Item 5.**Development Application: 22-24 Billyard Avenue, Elizabeth Bay**

File No.: D/2018/1286

| Proposal Summary: | <p>The application is referred to the Local Planning Panel for determination due to the proposed development exceeding the height of the buildings standard by 35.3%.</p> <p>The application proposes alterations to the balcony area of apartment 5 within the Del Rio building. Work includes removal of the windows enclosing the existing balcony, reconstruction of the balcony openings to their original detail, addition of a new a sliding glass door to access the balcony and adjustment of the roof pitch to raise the height of the eaves by 335mm.</p> <p>Amendments have been made to the application to address concerns regarding the design of the balcony openings as well as further resolution of the roof details and their intersection with the adjacent Spanish mission detailing.</p> |

Figure 6: Proposed east and north elevation

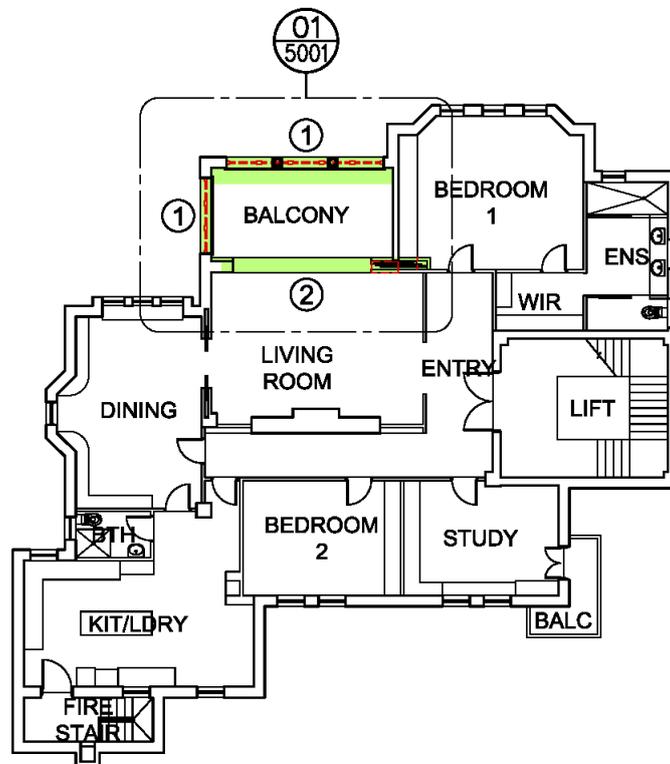
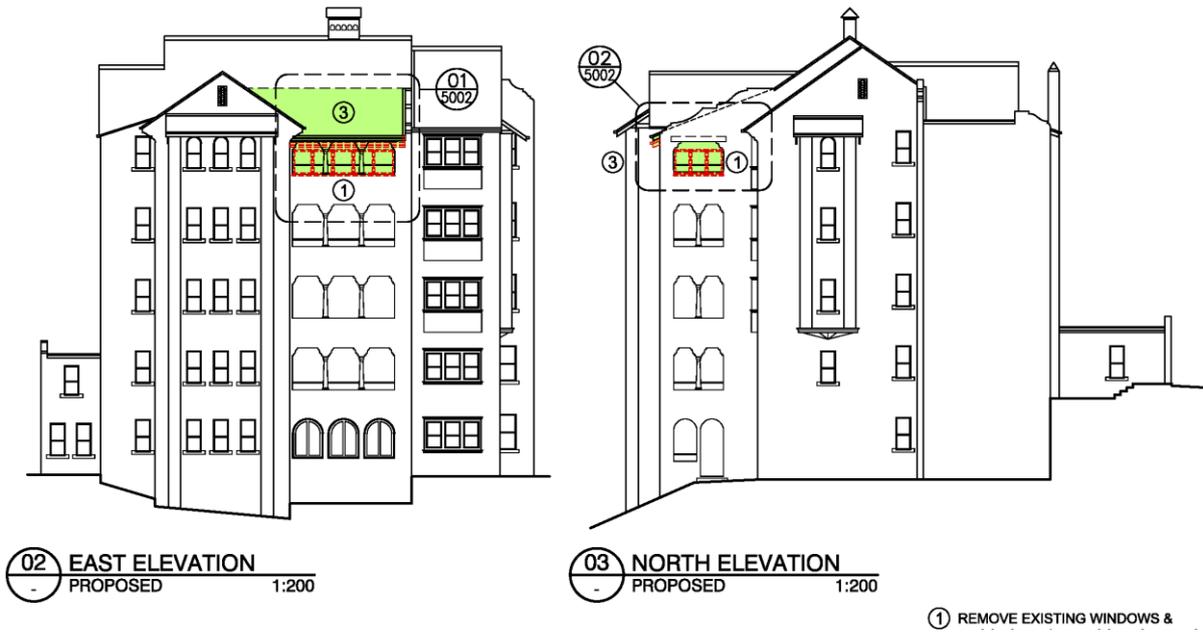
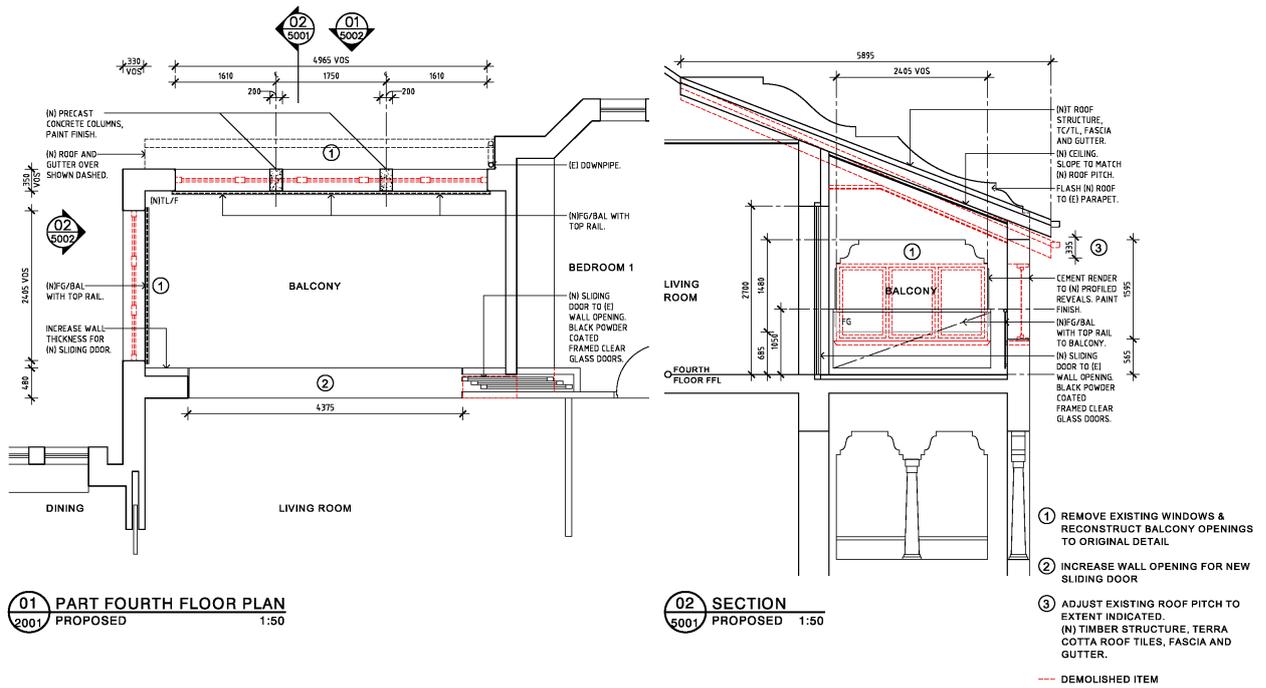
6. The development application has been amended during the course of the assessment. Council staff requested amendments to the proposed development in relation to the recreation of the original balcony openings. It was requested that the new balcony openings match the original 1929 approved Council drawings. See Figure 8. Further clarification was also required in relation to the roof details and their intersection with the adjacent Spanish mission detailing.

7. Amended details were submitted that reinstate the balcony openings to original details based on the original 1929 drawings by John Spencer Stansfield and roof details were submitted to the satisfaction of Council's Heritage and Urban Design specialists.

Figure 10: Height of proposed work and existing building

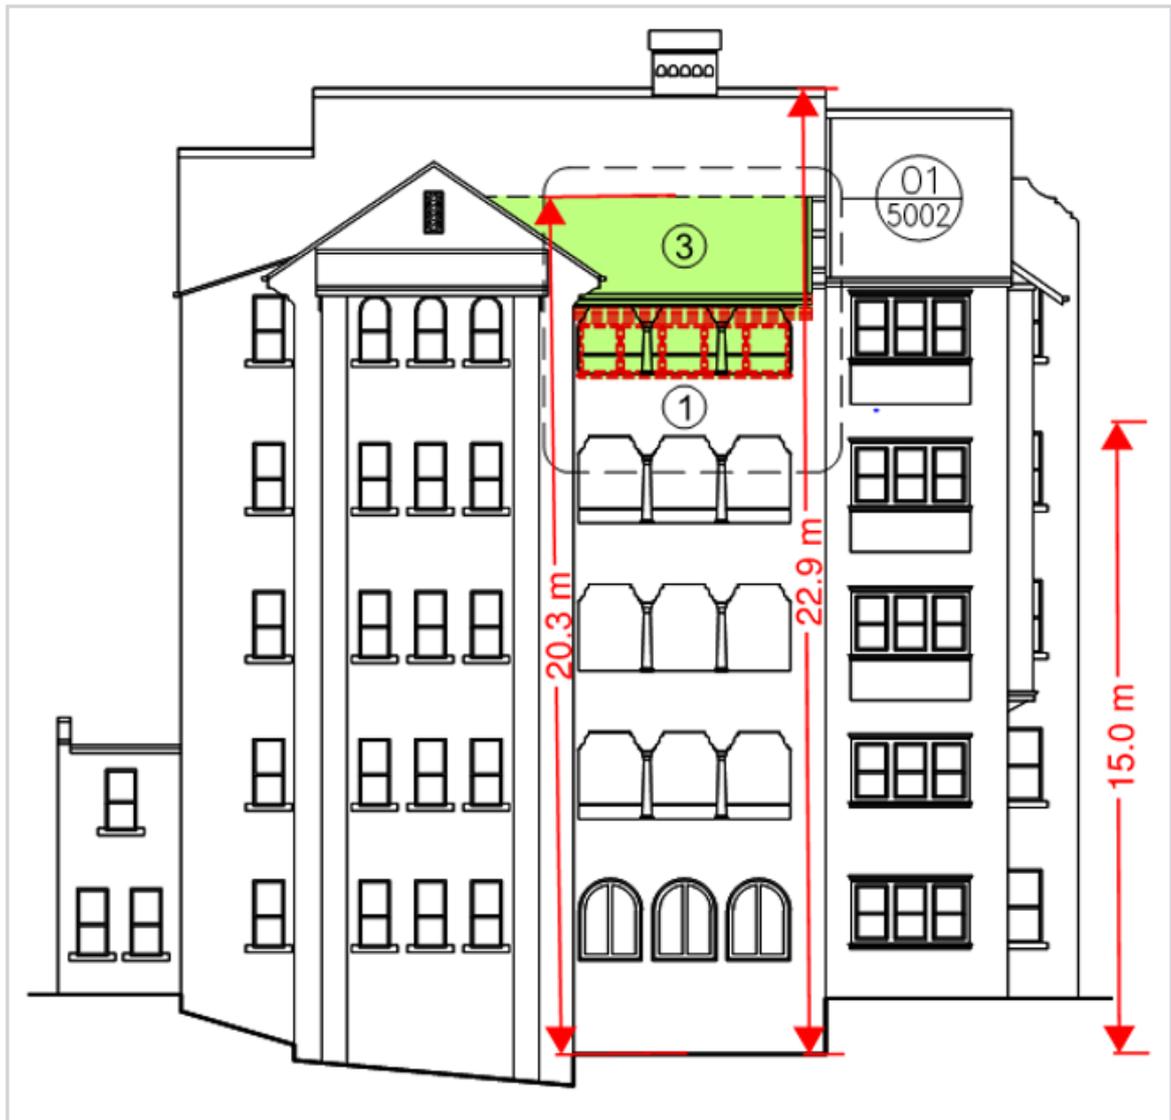
21. The Sydney LEP 2012 permits a maximum height control of 15m. The proposed alterations will occur at a maximum height of 20.3m. The variation to the building height LEP control results in an exceedance of up to 5.3m, or 35.3%. See Figure 10 below.

26. For the reasons outlined above, there are sufficient environmental planning grounds to justify contravening the building height development standard and it is recommended that a Clause 4.6 be granted.
